RE: RESPONSE TO FURTHER ADVICE

Multiple Dwelling (8 units)
COUNCIL REF: 31785733
48-52 Woodstock Avenue, Taringa QLD 4068
Lot 1 & 2 on RP56063

Figure 1 – Required section drawings

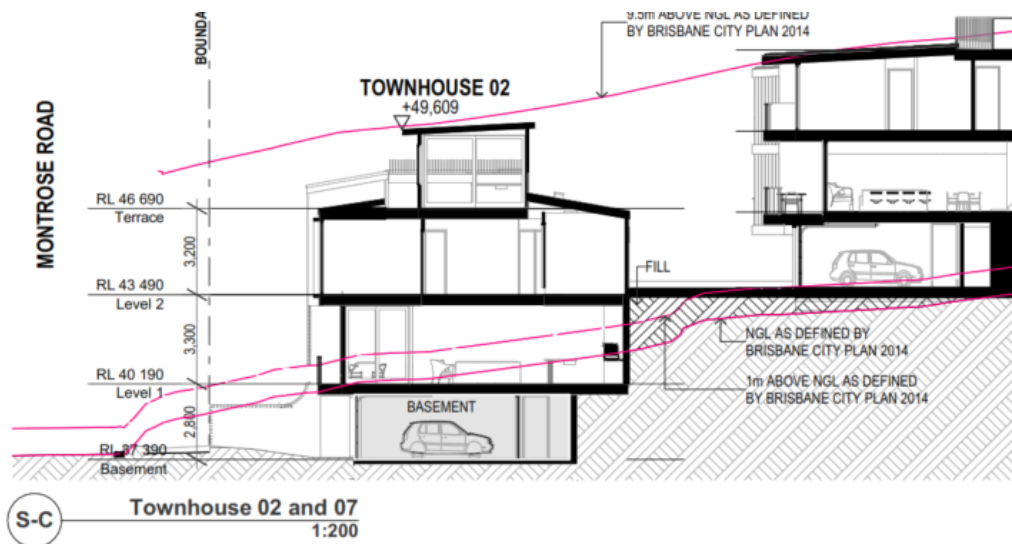
- 1) A full assessment in relation to the building envelope and its visual dominance has not been undertaken due to information not being provided.
 - a) Provide sections as shown in Figure 1 to provide clarity on the height of the proposed Units 1 and 2.

Response: Please find attached as **Appendix A**, a revised set of architectural plans which includes the request information.

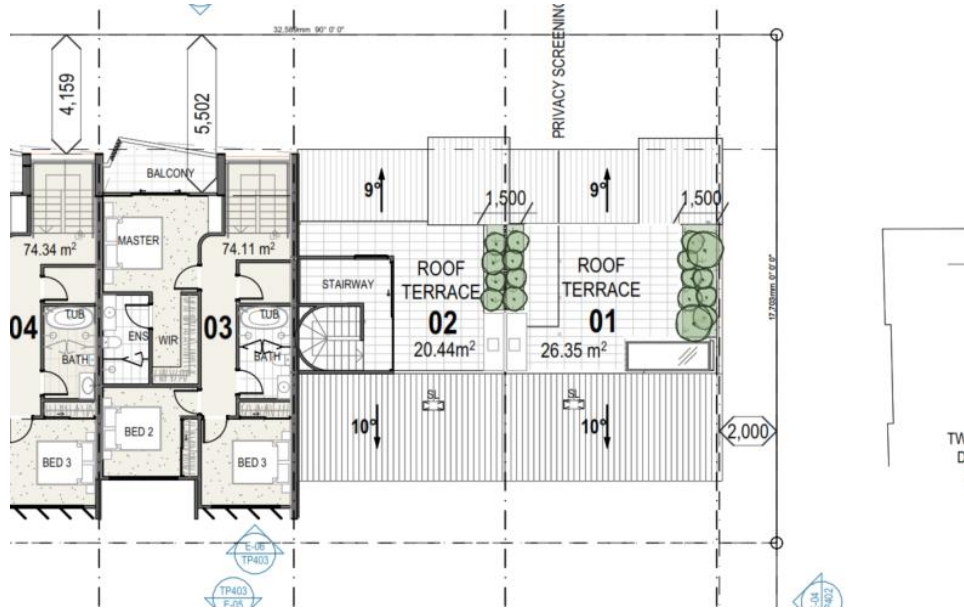
b) Ensure that the rooftop of Unit 2 does not constitute a storey.

Response: Please find attached as **Appendix A**, a revised set of architectural plans. This demonstrates that Unit 2 doesn't exceed 3 storeys in height. For quick reference refer to the below snip which shows the basement is not considered a storey as per the City Plan 2014 Definitions.
